MINUTES

Resolution No. 26-05

A Conditional Use Permit In Accordance With MSB 17.30 - Conditional Use Permit For Earth Materials Extraction Activities To Extract Approximately 360,000 Cubic Yards Of Gravel Over 10 Years Located At 20254 West Susitna Parkway (Tax ID#16N04W03A009), Within Township 16 North, Range 4 West, Section 3, Seward Meridian.

A RESOLUTION OF THE MATANUSKA-SUSITNA BOROUGH PLANNING COMMISSION APPROVING A VARIANCE TO MSB 17.55.020 FOR THE CONSTRUCTION OF A DWELLING TO BE PLACED APPROXIMATELY 32 FEET FROM THE SHORELINE OF MIDDLE CASWELL LAKE SUBDIVISION, PLAT #68-10, PALMER RECORDING DISTRICT, STATE OF ALASKA, LOCATED AT 49562 S Lure Circle, TAX ID 6070000L1051.

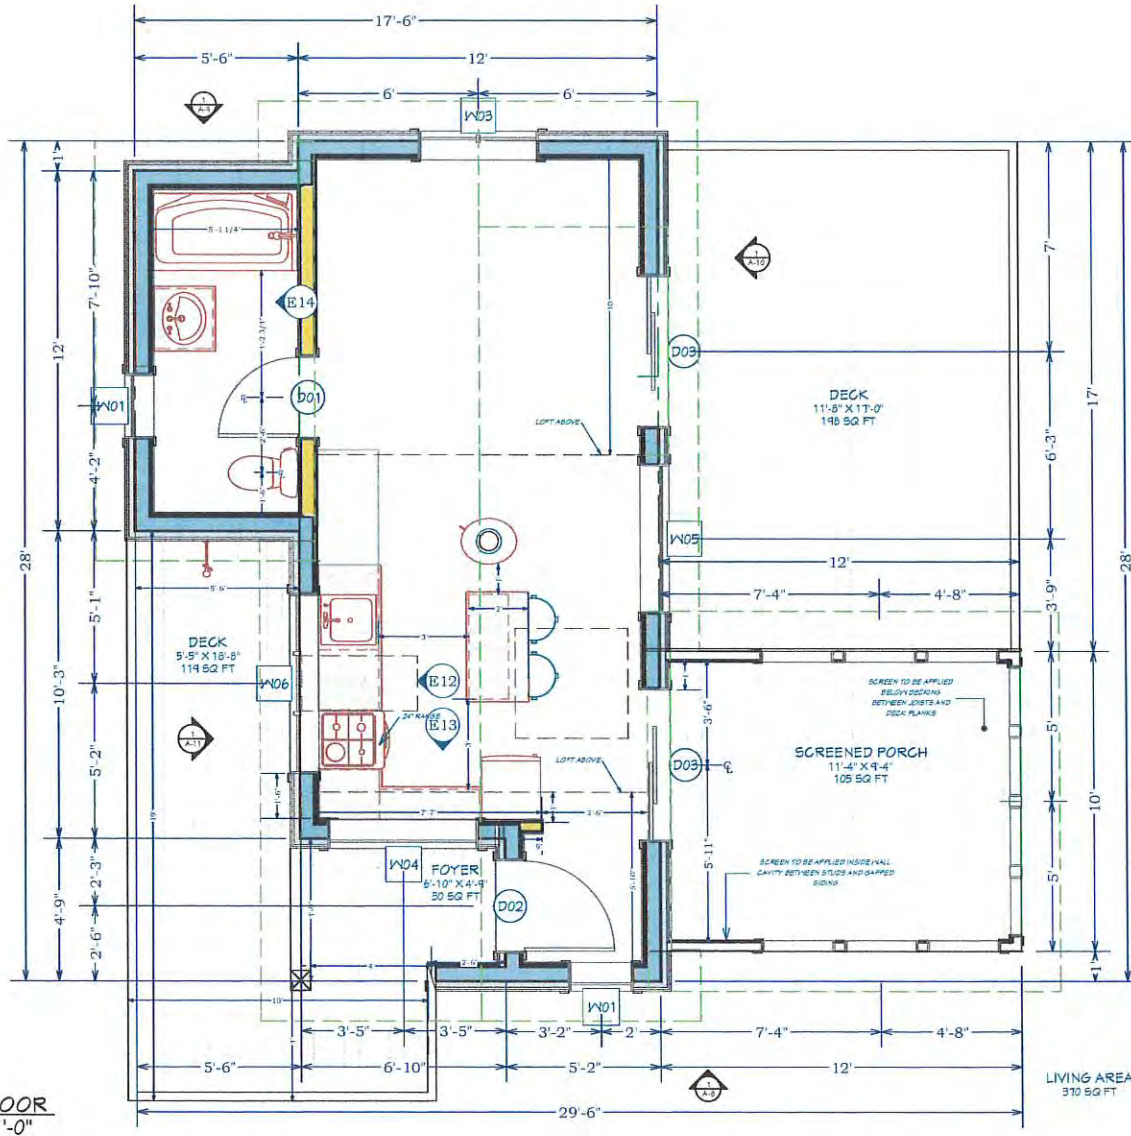
At this time, the current site plan shows that there is buildable area available that is not being utilized. Because of this, I am unable to recommend the plan as it stands. R&K Land Surveying's review indicates that portions of the property can meet the 75-foot setback, as well as other required setbacks, and this area has not been incorporated into the proposal.

Thank you for your recent variance application and the supporting materials you submitted. After reviewing the surveyed site plan, we determined that the proposed house location does not fall within the buildable land area available on your lot. For this reason, your variance request as currently submitted will fail to be recommended.

- You may revise the plan to minimize encroachment into the waterbody setback area, and all other applicable setbacks.
- If your revised design fits fully within the buildable land area, I will be happy to issue a refund for the application fee.
